**WG3-U73-ERD-S-0005 Revision 3**

**Control Building and Reactor/Fuel Building Complex  
Seismic Structure-Soil-Structure Interaction Analysis Report**

**Document Name**  
**Revision 2 to Revision 3 WG3-U73-ERD-S-0005 Change List**

Figure 4.3-7 CB-RB/FB Combined Model Input Full Column Subgrade Profiles

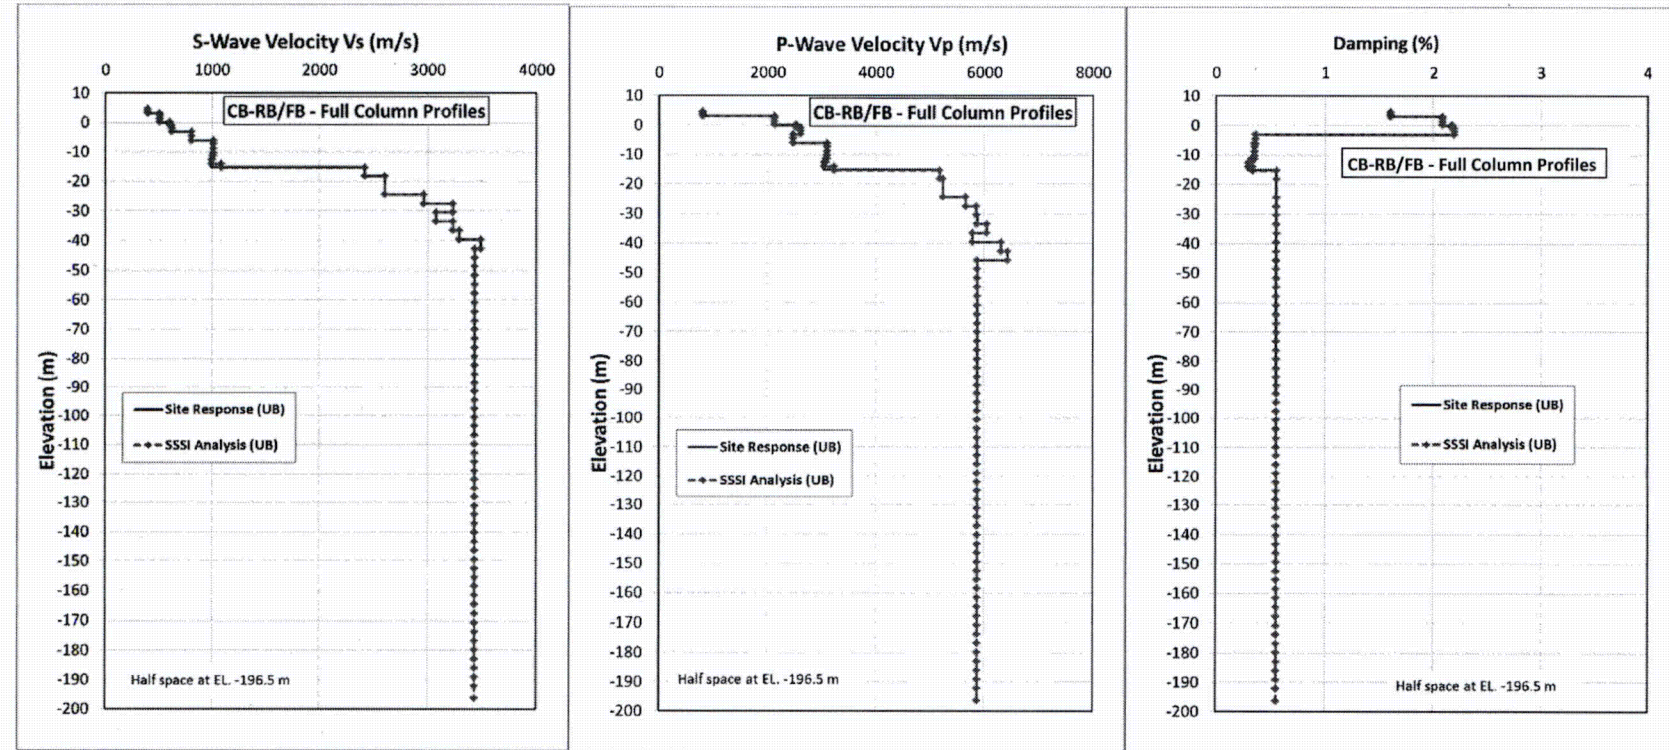
<b>Item</b>	<b>Location</b>	<b>Description of Change</b>
10.	Section 6, 5 <sup>th</sup> para., Item e.	Revised to update the description of the criteria and approach used for enhancing CB ISRS to bound SSSI effects of RB/FB and FWSC.  Item e. changed to:  "Broaden the peaks of the amplified ISRS obtained in Step d. by $\pm 15\%$ and then fill the valleys to obtain the enhanced design ISRS that bounds the effects of both the concrete cracking and the <del>RB/FB</del> SSSI <u>of the RB/FB and FWSC</u> on the CB response."
11.	Table 4.2-1	Corrected formatting issues.
12.	Figure 4.3-7	Corrected title for Figure of damping.

Figure 5.4-3 Comparison of ISRS for CB Response in Vertical (Z) Direction

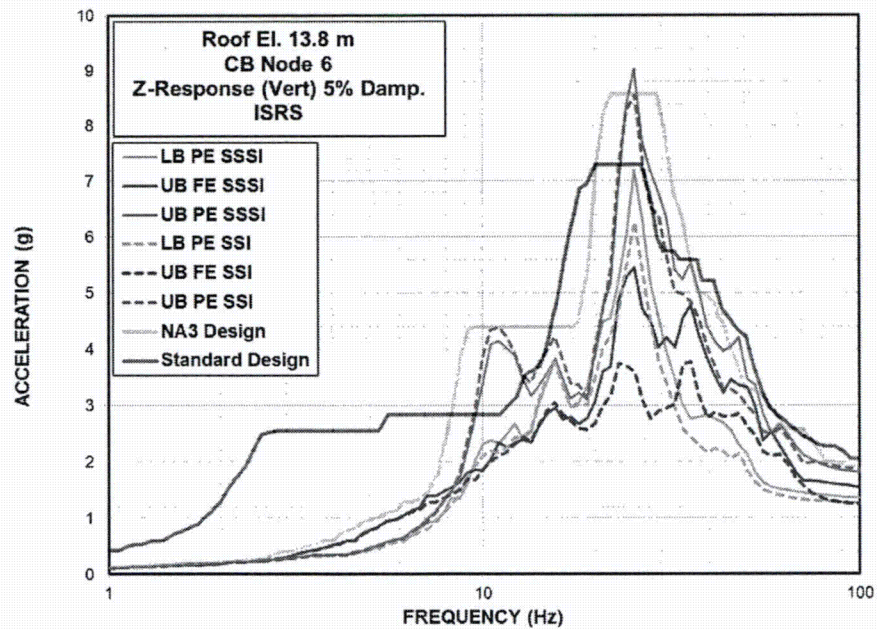
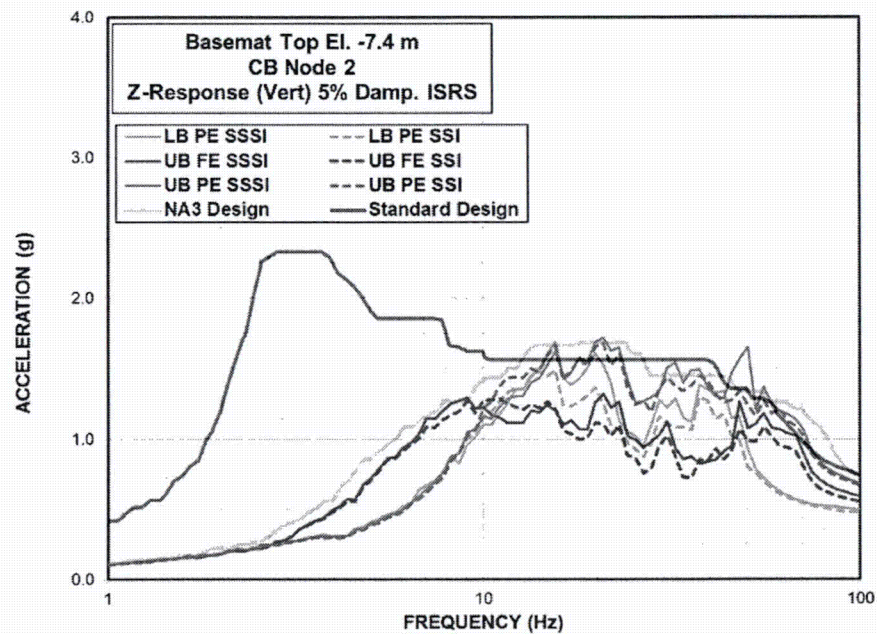
3.	Section 5.5, 5th para.	Added "exterior" as clarification for $Q_{xi}$ , $Q_{yi}$ .
4.	Section 5.6, last sent.	<p>Revised as follows to clarify that exceedance of ISRS peak is at frequency close to 50 Hz:</p> <p>"The SSSI induced sharp peak exceedance of the ISRS for the vertical response at the top of the CB basemat, shown in Figure 5.4-3, occurs at a high frequency close to 50 Hz."</p>

Figures 5.4-1 through 5.4-3 provide a comparison of the 5% damped ISRS obtained from the site-specific SSSI analyses of the CB-RB/FB combined model with the corresponding 5% damped NA3 site-specific design and standard design ISRS shown with thick blue and black lines, respectively. The NA3 site-specific design ISRS that are broadened by  $\pm 15\%$  and valley filled, represent the envelope of the ISRS results from the site-specific SSI analyses of the CB standalone model and serve as the basis for the site-specific design and qualification of CB equipment and components. The comparisons show that the ISRS representing the EW response at the top of the CB basemat obtained from the SSSI analyses of UB partial and full column profiles exceed the corresponding NA3 site-specific ISRS at frequencies greater than 30 Hz. The effects these exceedances have on the design are negligible because the standard-design ISRS for the horizontal response at the top of the CB basemat envelope the ISRS obtained from the site-specific SSI and SSSI analyses. The SSSI induced sharp peak exceedance of the ISRS for the vertical response at the top of the CB basemat, shown in Figure 5.4-3, occurs at a high frequency close to 50 Hz.
